Decision Notice and Finding of No Significant Impact

Flank Vegetation and Fuels Management Project and Forest Plan Amendment

**Bend/Ft. Rock Ranger District, Deschutes National Forest
Deschutes County, Oregon**

Figure 19. Short and Long Term Changes to $\geq 20"$ dbh Snags (Snags/Acre by Year)

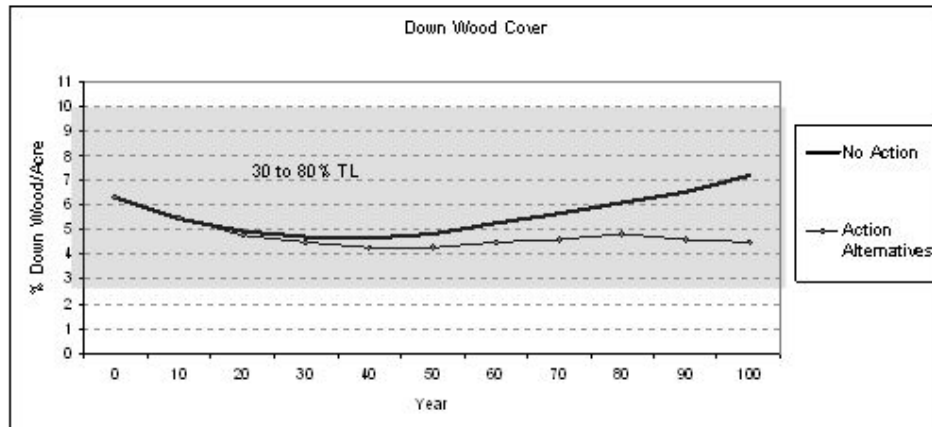
Comment #10: The figures showing average diameter are neat but to reveal a clearer picture, the EA should also disclose the effects on forest density and loss of snag recruitment. Comment included example figures. (1)

Response to comment #10: The EA for Flank project shows the estimated tree sizes and densities. Effects of snag and downed wood supply are described in the EA on pages 76 and 78 as well as 103-109. These pages identify the risk to mortality from beetles and fire. Since these events are stochastic and cannot be easily predicted modeling captured mortality has been addressed by beetle and fire risk. Snag levels were modeled to give an estimate of what may be available over the decades. The sheer number is not an indicator of the total desired habitat. Historically snags in the open dry ponderosa pine type were random and few, or stochastic and numerous. Models estimate tree mortality mathematically but based on stocking levels. Models do not estimate clearly the methods of mortality. With fire, mistletoe stress, drought stress, bark beetles and weather more methods of mortality are present for all stands dense or open. Mathematical estimates of density related mortality are those present in models and not similar to the low density open stands found in the dry ponderosa pine type. The mortality vectors in the ponderosa pine are not only dependent on density, as in more moist sites, but the inherent rough living conditions of the dry pine type.
